Block 16 Section 10

1.0 Context and Character

Context and Character London Circuit & City Hill

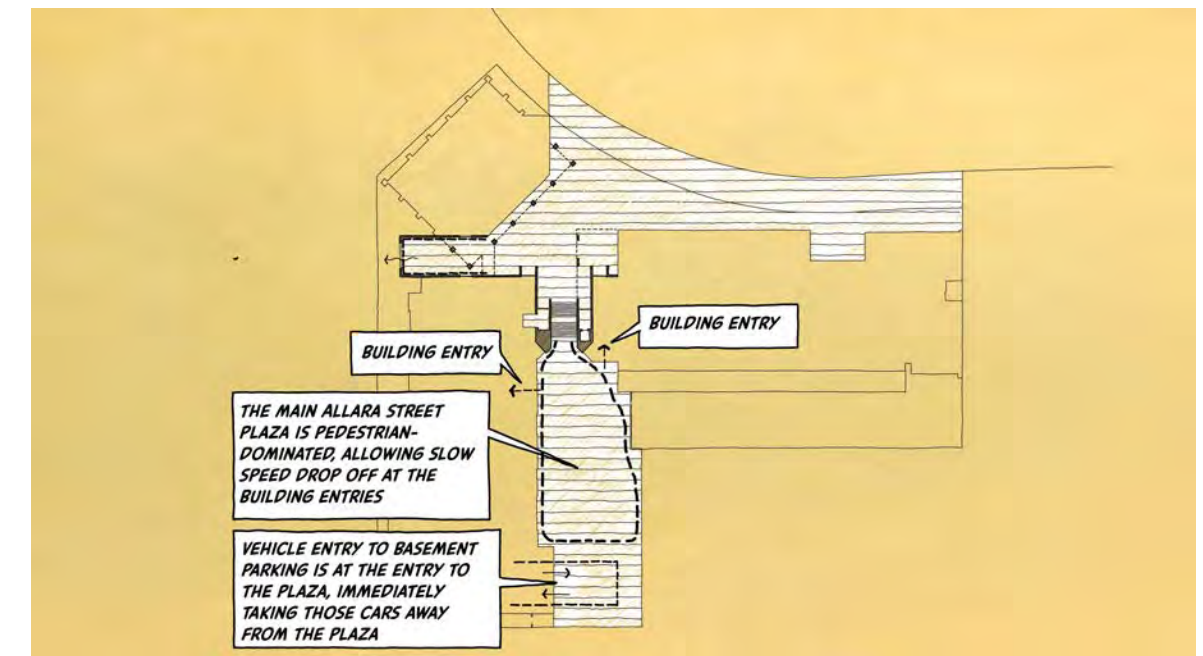
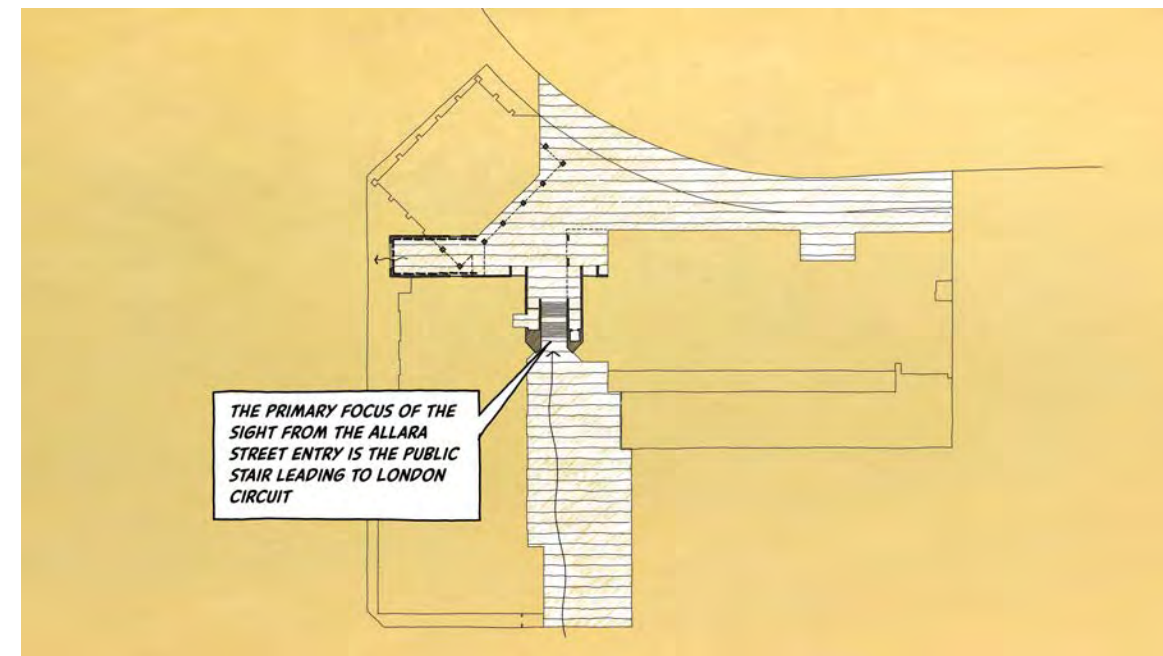
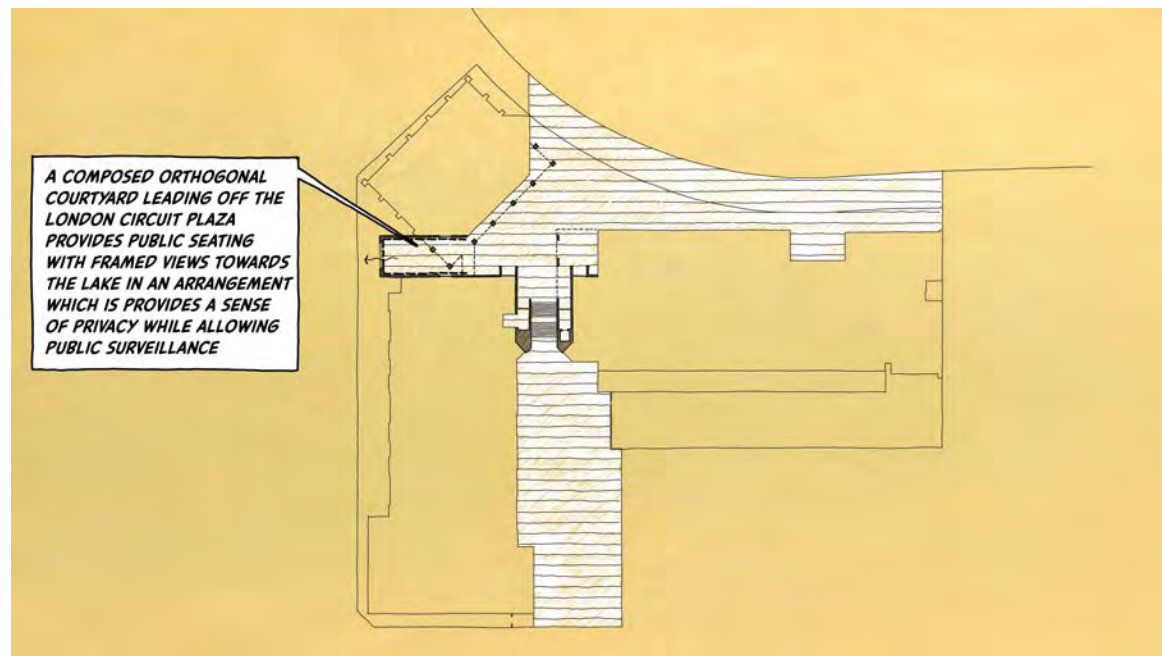
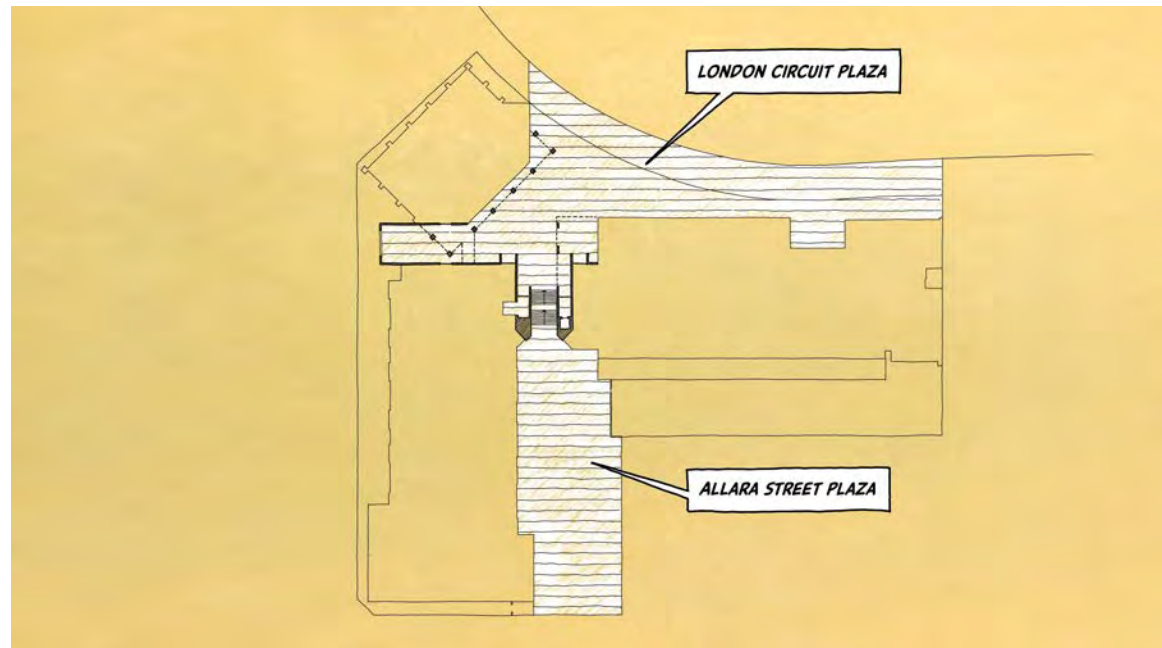
1.1 As the subject site is prominently located on London Circuit and fronts the City Hill precinct, the Panel notes that consideration should be given to the development's contribution to the evolving character of this location. The National Capital Plan and the City Plan both identify the desired future character area of City Hill precinct as the pre-eminent civic and cultural core of the city. The Panel considers that development on London Circuit, noted as the city's premier business address, should reflect this desired future character through high quality architectural and public domain outcomes. The proponent encouraged by the Panel to further refine the design proposition to provide a contextually appropriate response to the site's context and character.

Context and Character The Jewel

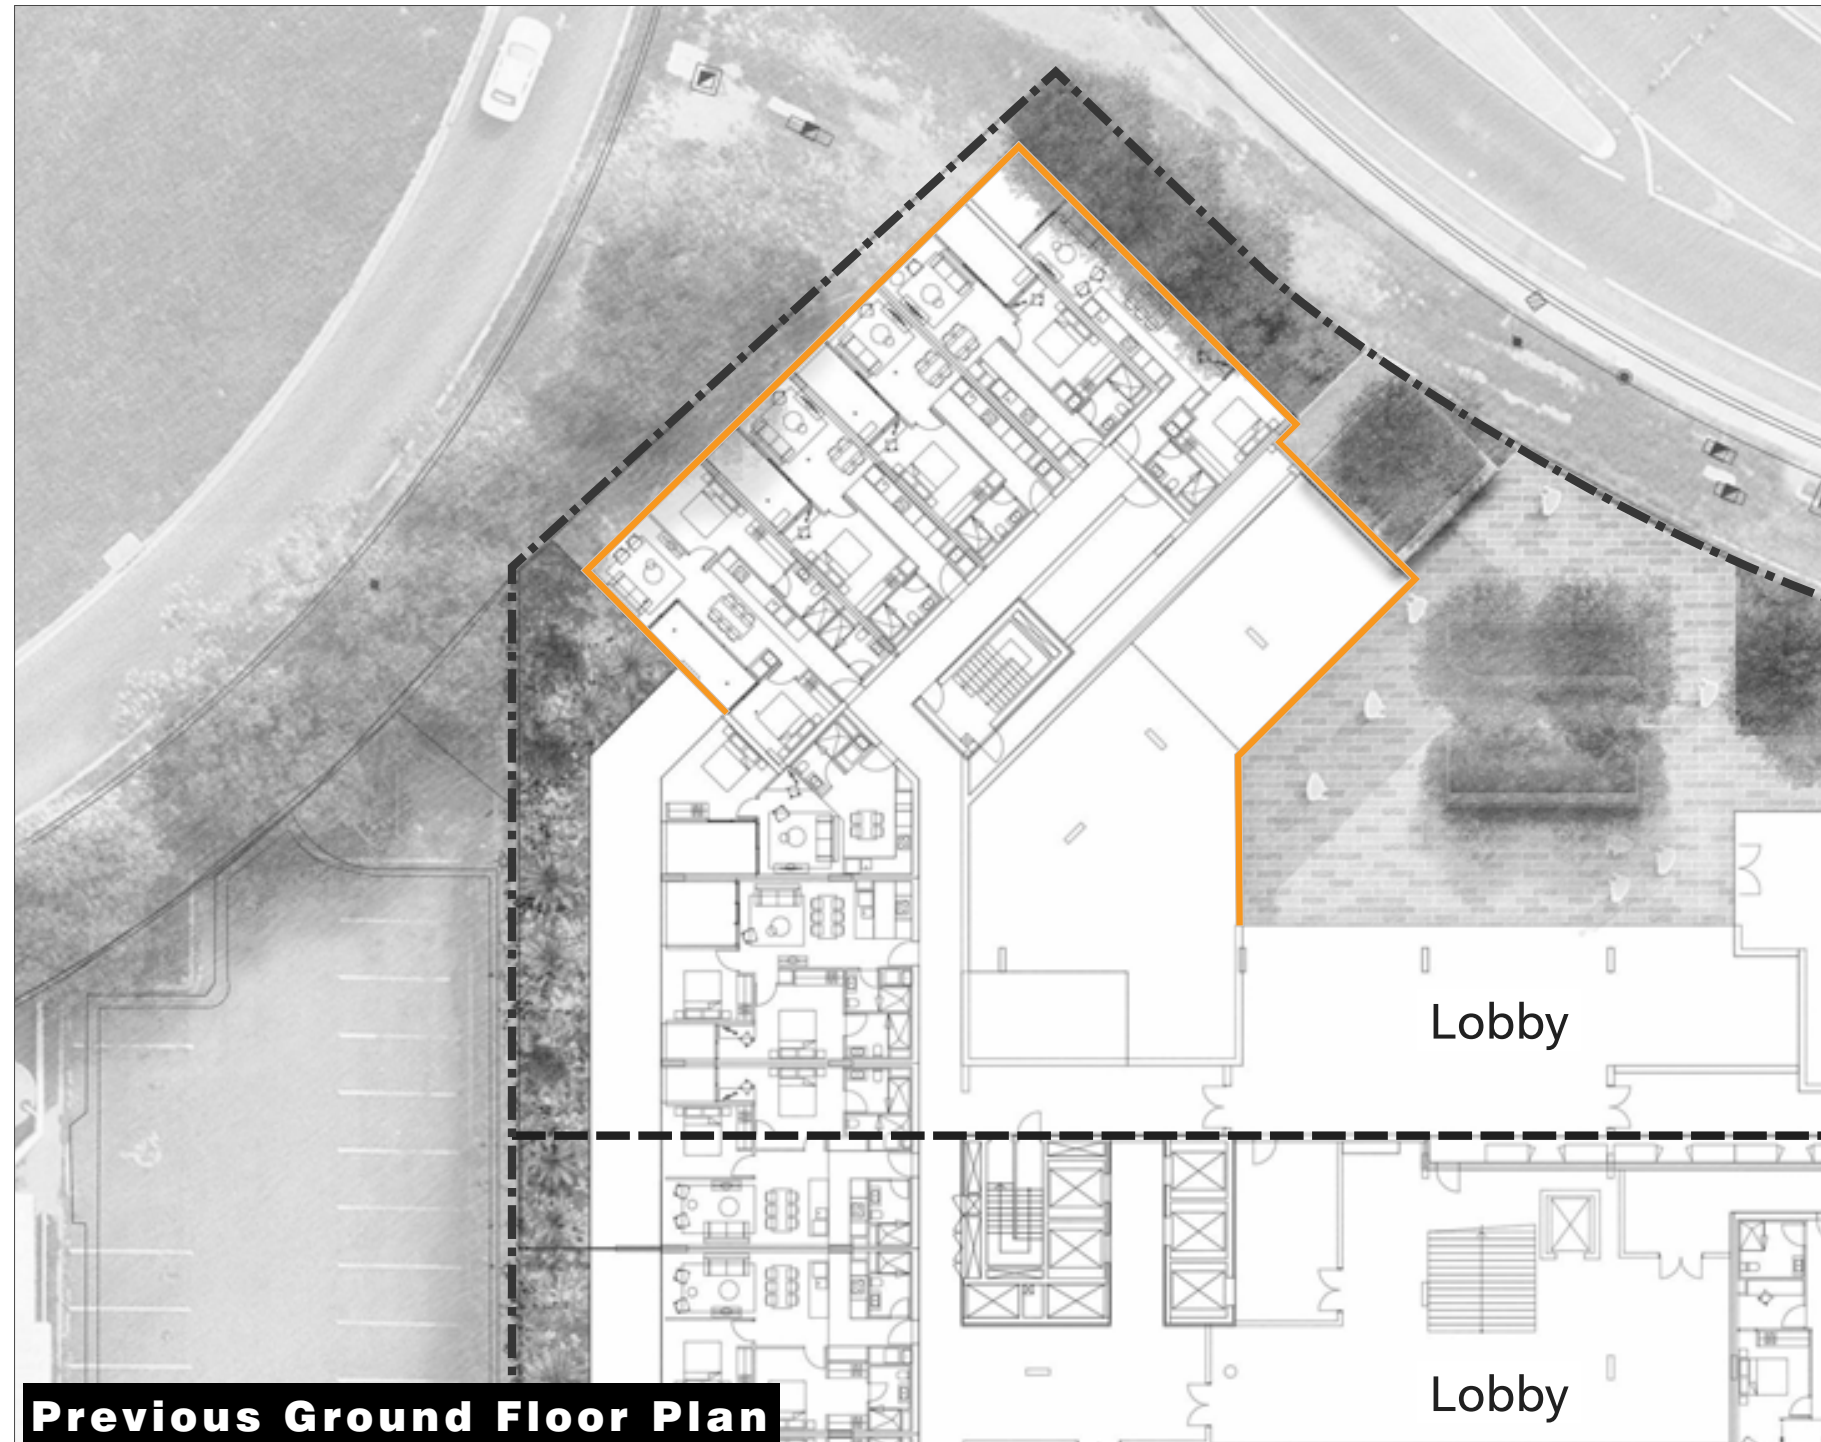
1.2 The amended building alignment proposed is acknowledged by the Panel as an improvement from the initial proposal, however, the Panel considers further design development is required to address the single large footprint of the proposal (see 4.1) and the current distortion of the London Circuit geometry to the west of the site. This may include reconsideration of the alignment of the 'Jewel' building to align with the London Circuit southern edge geometry and division of the proposed connected building forms on the site.

Context and Character Future Roads

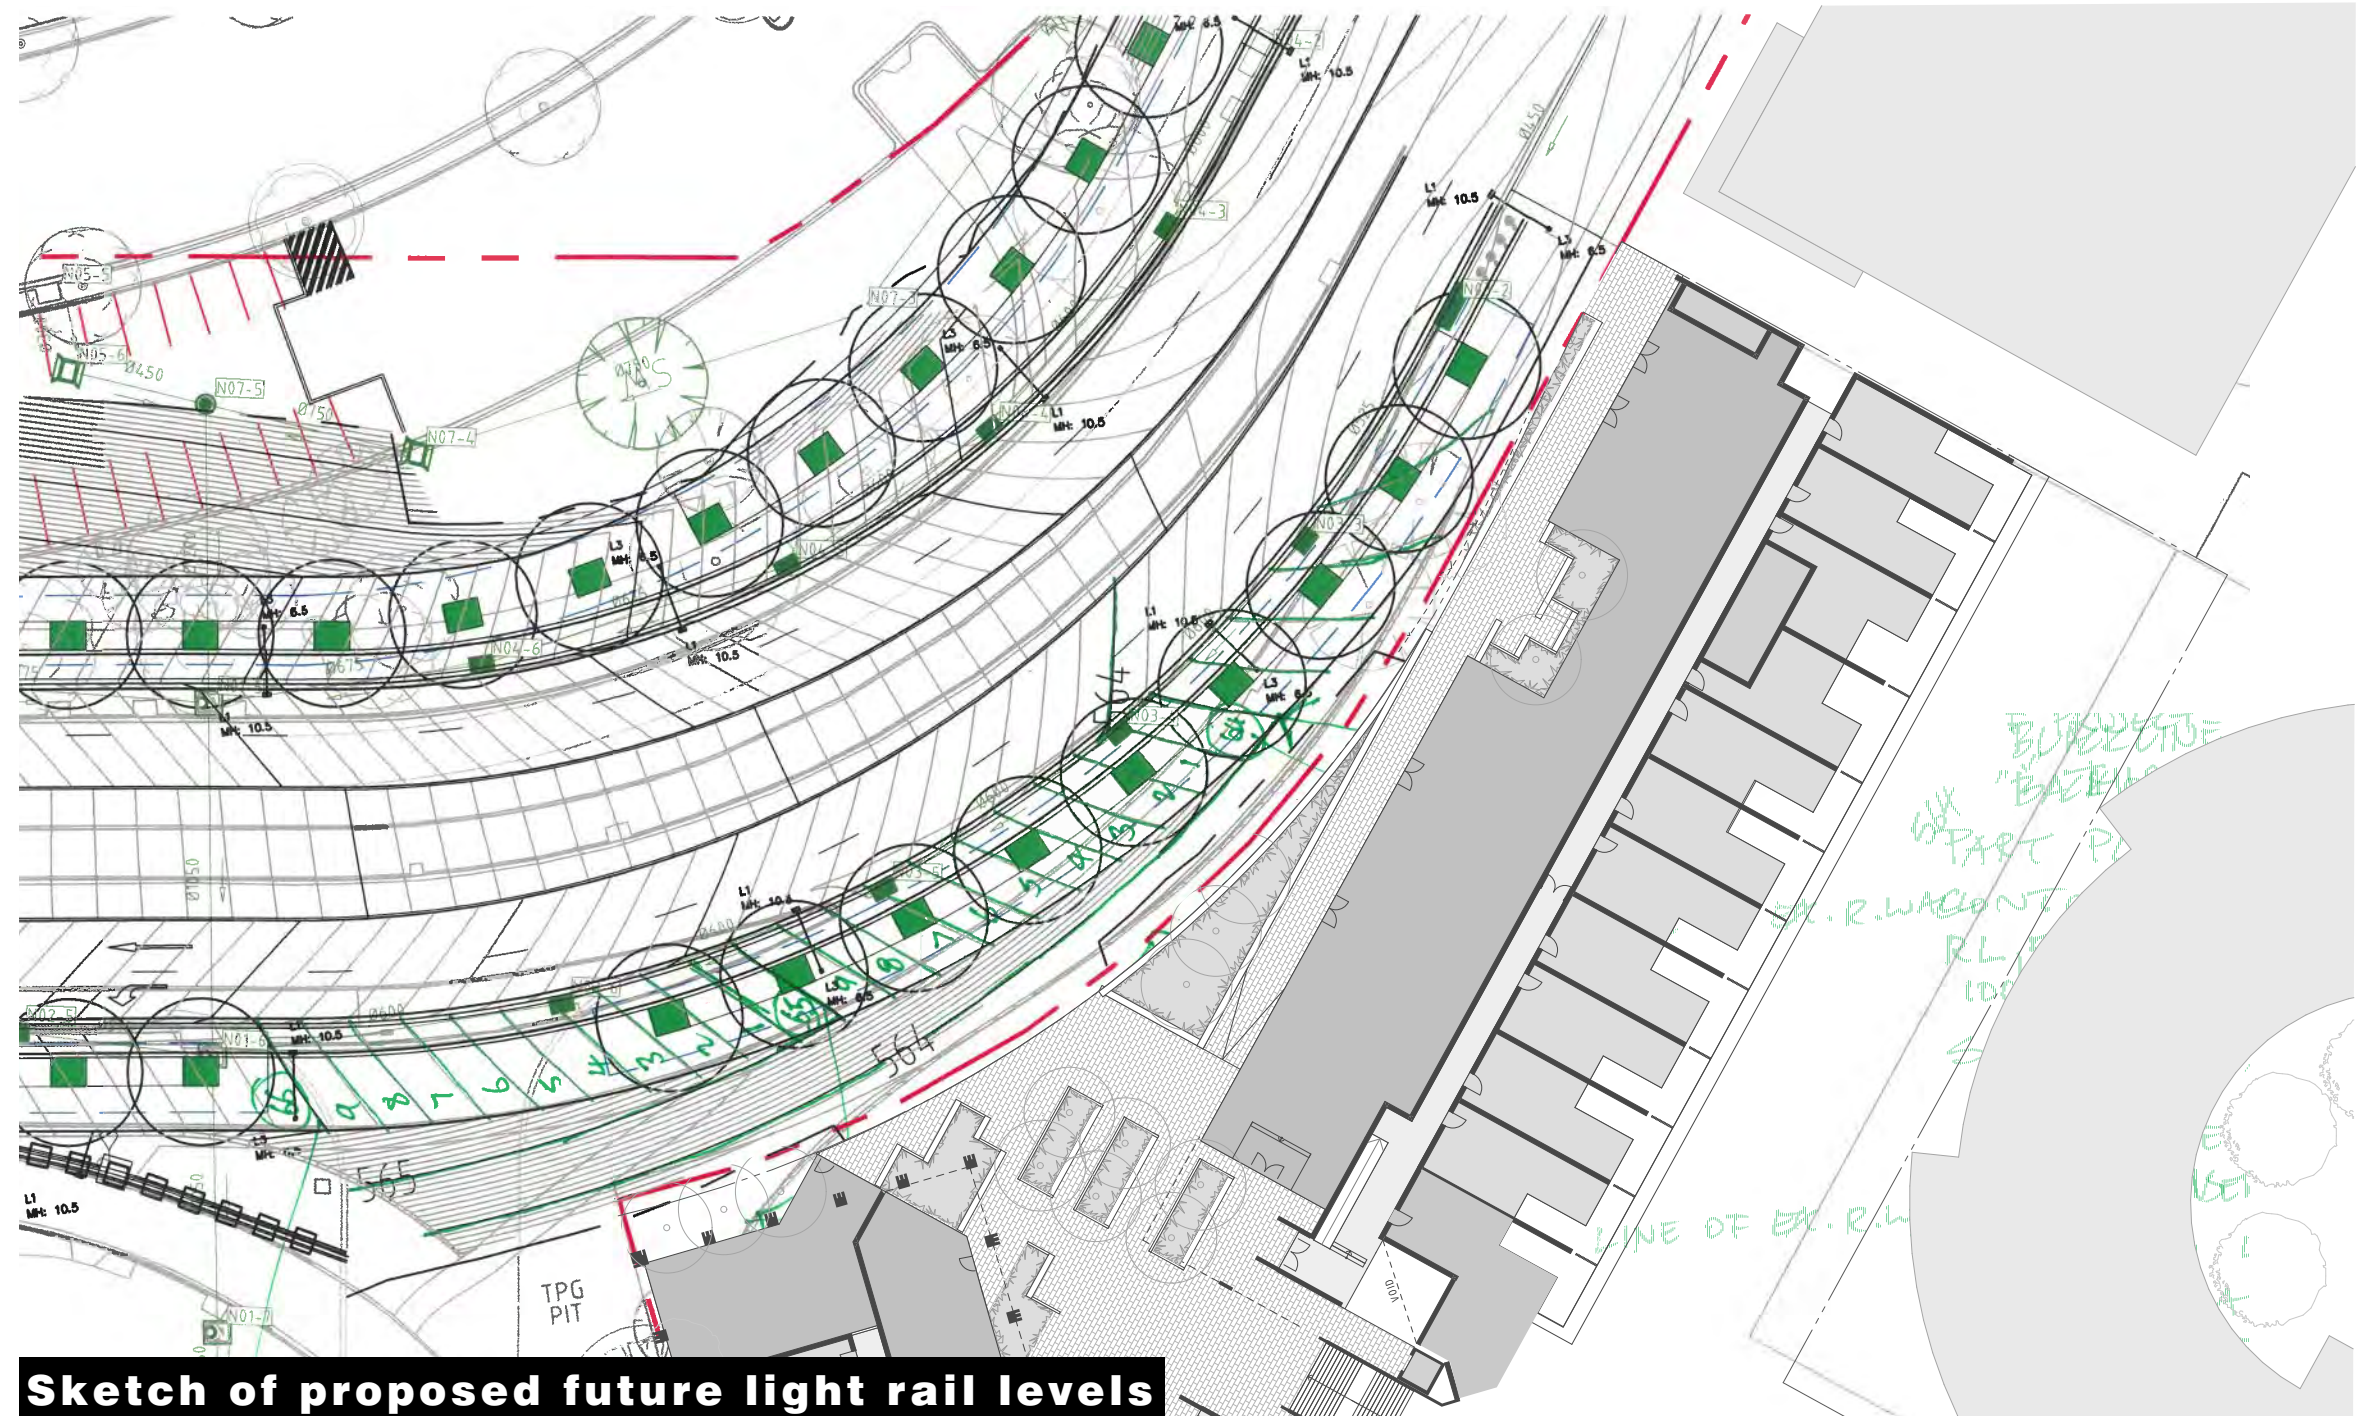
1.3 Noting the recent extension of roadways within the City Hill Precinct (i.e. Constitution Avenue and Edinburgh Avenue) and future Light Rail Stage 2 works to London Circuit, the Panel considers that opportunities exist for the proposal to better respond to the anticipated future road link and the removal of the Parks Way / London Circuit 'clover leaf' (see Constitution Avenue and Anzac Parade Precinct Code, Figure 69). The Panel considers that these works will significantly change the current western boundary interface for the subject site. As such the Panel recommends that the proponent team continues to undertake engagement with relevant entities including EPSDD, CRA, NCA, TCCS and MPC to establish a better understanding of the future outcomes anticipated for the adjacent land use and arrangements. This engagement is considered by the Panel as crucial in enabling the proposal to appropriately respond to and explore opportunities on the western edge of the site to the benefit the development and the public.
